## Board of Adjustment

### *Staff Report*

**CASE NUMBER:** BOA17-00182  
**LOCATION/ADDRESS:** 6700 block of E McKellips Road south side  
**COUNCIL DISTRICT:** District 5  
**STAFF PLANNER:** Lisa Davis, AICP, Planner II  
**OWNER:** Toms Holding, LLC  
**APPLICANT:** 4G Development & Consulting, Inc.- Ryan Robinson

**REQUEST:** *Requesting a Development Incentive Permit (DIP) to allow the development of a restaurant with a drive thru in the LC district.*

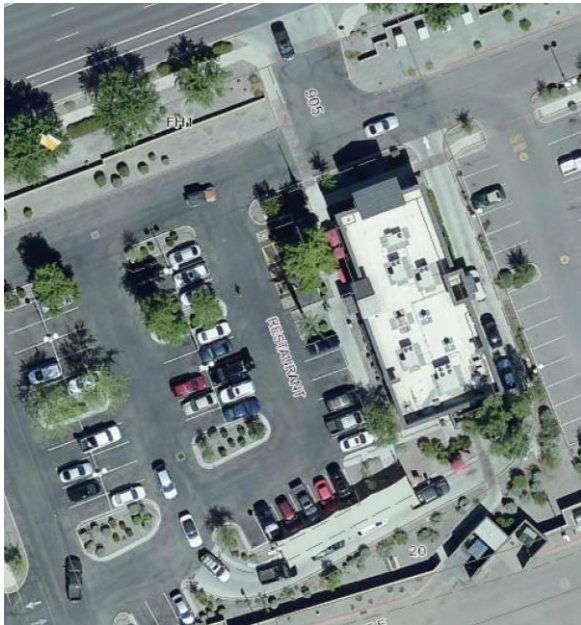
Development Standard	MZO Requirement	Applicant Proposed	Staff Recommended
<b>Setback (building/landscape)</b>			
McKellips Road	15'	5' for a distance of 50' 15' everywhere else	As proposed
Power Road	15'	Landscape- 27'	Meets MZO
West Property Line	25'/20'	Landscape-25 feet	Meets MZO
South Property Line	0'	Landscape-15'	Meets MZO
<b>Landscape material adjacent to street</b>			
McKellips Road 484'	Total of 19 trees	Total of 9 trees	Numbers and sizes shall meet MZO requirements.
Power Road 138'	Total of 6 trees	Total of 3 trees	
<b>Foundation Base</b>			
North elevation	15 feet	11.5 feet	15' per MZO
East elevation	15 feet	15 feet	Meets Code
West elevation	5 feet	5 feet	Meets Code
South elevation	5 feet	5 feet	Meets Code
<b>Landscape material at Foundation Base</b>	6 trees total	6 trees total	Meets Code
<b>Landscape islands</b>	Required at each end row of stalls and every 8 spaces	Elimination at the end of the row in middle portion of parking field	Landscape islands shall be installed to meet MZO

<b>Bicycle parking</b>	Min 3 spaces	None	Min 3 spaces
